**ISO/IEC JTC1/SC29/WG11 MPEG2015/M35847
February 2015, Geneva, Switzerland**

Source **Telecom ParisTech, Canon Research Centre France**
Status **For consideration at the 111th MPEG Meeting**
Title **Clarification on Layered HEVC over MPEG-2 TS**
Author Jean Le Feuvre, Cyril Concolato, Franck Denoual, Frédéric Mazé, Eric Nassor

Figure 1 - References and Operation Point for multiview example of Annex U

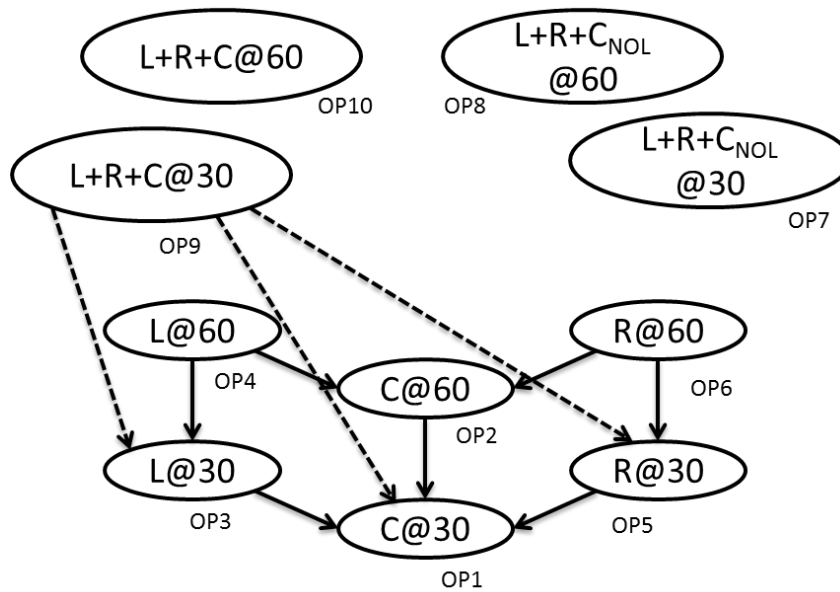
Implicit signaling of operation point is however an important feature for most simple use cases featuring a few layers, where each layer has only a single dependency to a lower layer, as shown in Annex U, as shown in Figure 1.

There could be cases where a layer is never an output layer in any operation points of the complete layered bitstream (for example the PID corresponding to OP2 in Figure 1). Such an awkward configuration could break implicit operation point discovery. There is a need for signaling this at the TS level. Several options could be used:

The figure U-4 gives the ordering of layers per PID with their respective stream types and associated operation point. The right view streams are labeled with operation point 9 for the 30fps stream and 10 for the 60 fps temporal subset.

However, according to the list of operation point given, op9 is the combination of central, left and right at 30 fps and op10 is the combination of central, left and right at 60 fps. Such operation points cannot be implicitly defined, since the hierarchy (extension) descriptors will not indicate a possible combination of left and right views together. We believe the correct values should be 5 and 6. If 9 and 10 are the intended OP, the associated hierarchy of dependencies should be indicated in the annex and the mention that there are no dependencies between Right and Left views should be removed.

We suggest removing the bullet in the clause and clarifying as follows clause 2.6.100:

“Some operation points can be implicitly found by following the hierarchy of dependencies of a component (PID), whether implicit or defined using Hierarchy Descriptor or Hierarchy Extension Descriptor. Profile/tier/level for such operation points can be found in the HEVC Descriptor defined for that component.”

1. Modify the Operation Point Descriptor by adding a flag signaling only that the operation points described by the descriptor are valid (i.e., disable implicit OP discovery). The drawback of this approach is that all initially implicit OPs have to be sent, thereby greatly increasing the size of the PMT.
2. Use a reserved bit of the HEVC Descriptor to indicate that the layer carried in this stream is never an output layer stream in any operation point.
3. Mandate that a Layered HEVC component (PID) with no HEVC descriptor shall not be used as an implicit operation point.

We recommend option 2 or 3.
